Re: 30ton Cargo Block of IHI and IHI-WMMP Deck Crane for log operation
木材荷役における IHI 及び IHI-WMMP デッキクレーンの 30ton カーゴブロックについて

1. Special notice for cargo block (カーゴブロックに関する勧告)

2. Method of cargo block reinforcement (カーゴブロックの補強策)

ABNORMAL CONDITION
(FOR EXAMPLE)

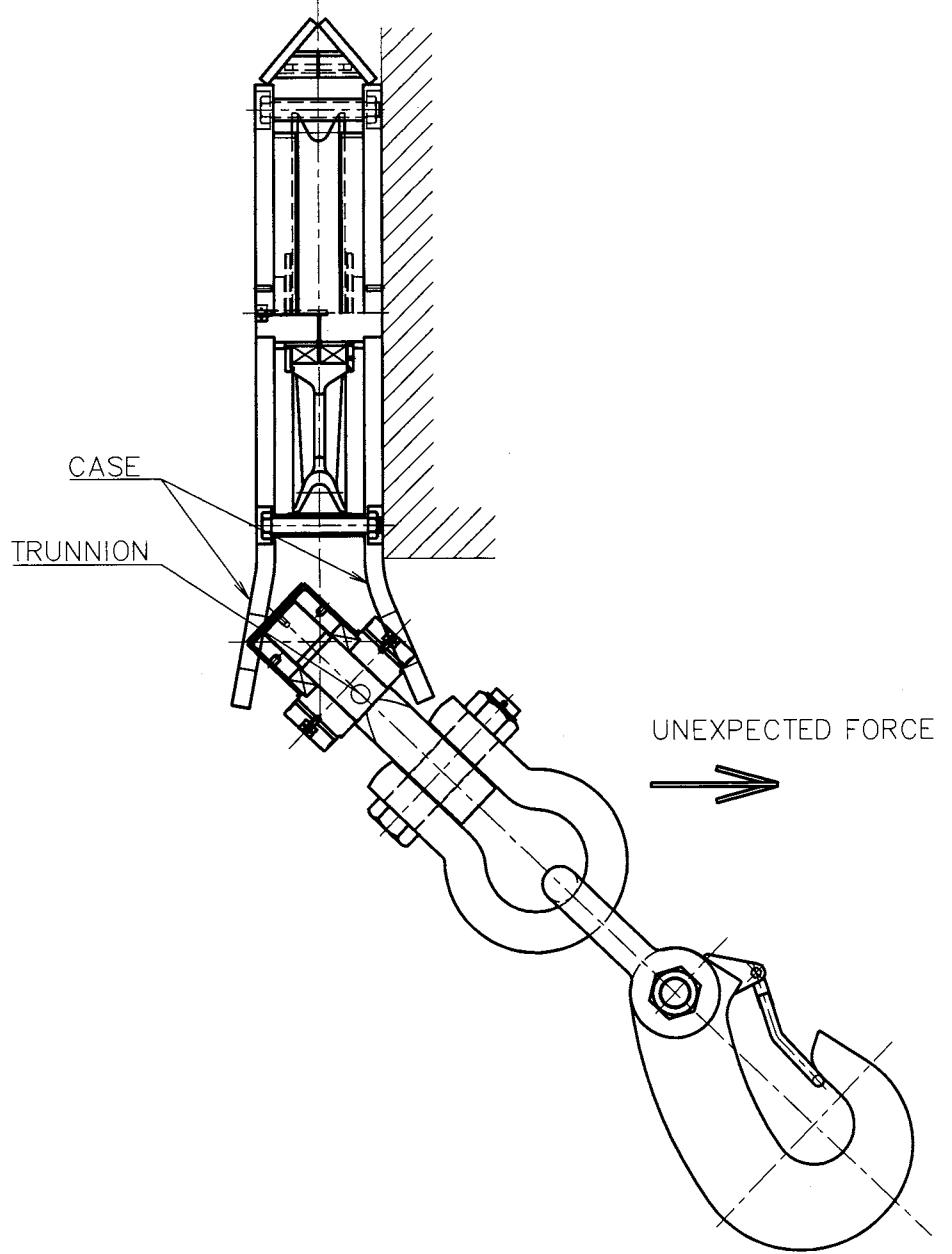
We had received the report of cargo block damage that the trunnion dropped out from cargo block's case in loading and unloading of log at New Zealand. (See attached P.3.)

JUN. 22 2011	C3-48325 单元作威			
NO. DATE	DESCRIPTION	DRAWN	DESIGNED	CHECKED
SCALE	1:5			APPROVED
1ST ANGLE PROJECTION	IHI MARK II DECK CRANE			22 TYPE
3RD ANGLE PROJECTION	30T CARGO BLOCK			
	ADDITIONAL BOLT			
JOB NO. FOR REFERENCE				
IHI HYDRAULIC MACHINERY DESIGN GROUP				
DRAWING NO. /

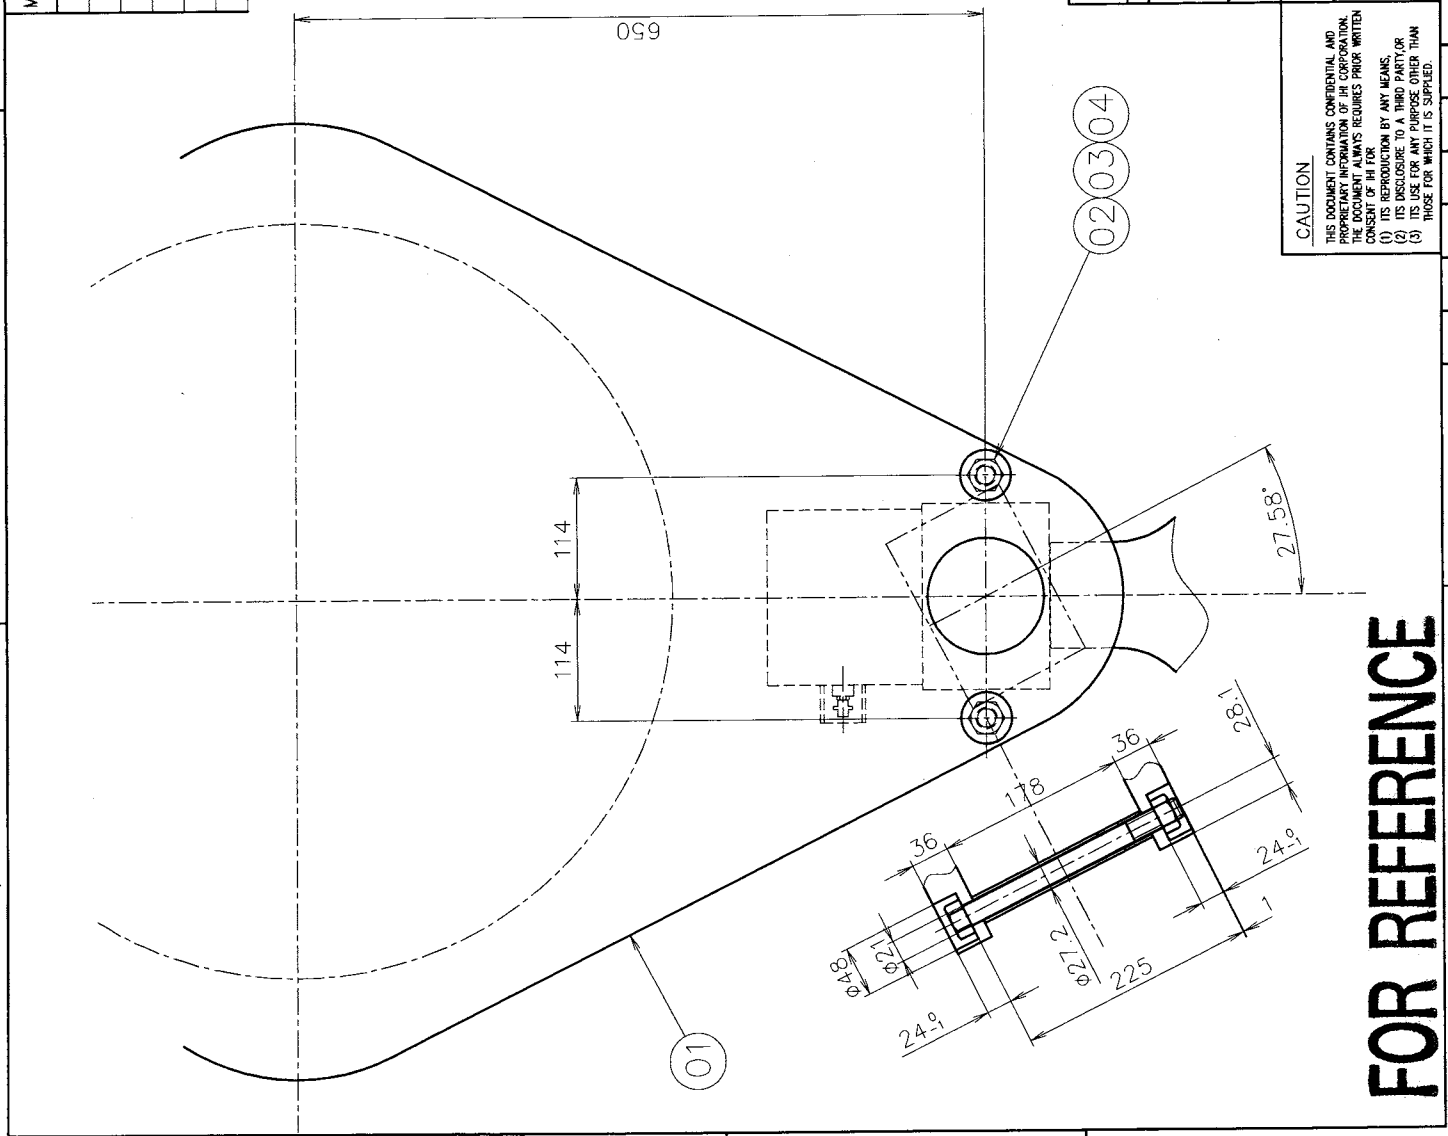
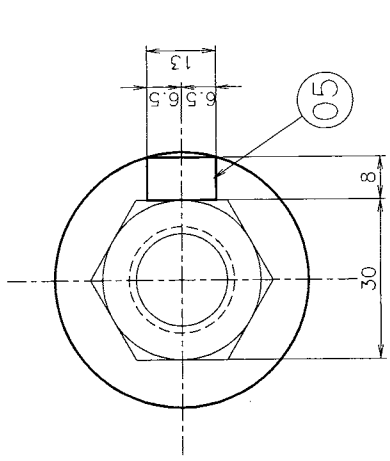
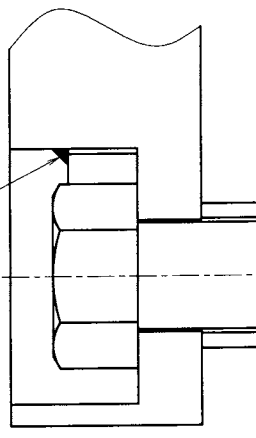
Regarding the delivered cargo block, we would like to propose you the best reinforcement plan (two bolts additional improvement plan) as a purpose of preventing the trunnion's drop out. (See attached P.4,5.) Please modify the cargo block before loading and unloading of log.

This reinforcement plan has strength of about 200% compared with standard cargo block. But, please check the daily inspection (deformation, defect, defective motion, etc.) to the cargo block before loading, during loading and after loading.

WELD AFTER TIGHTENING
BOLT AT STATED TORQUE.
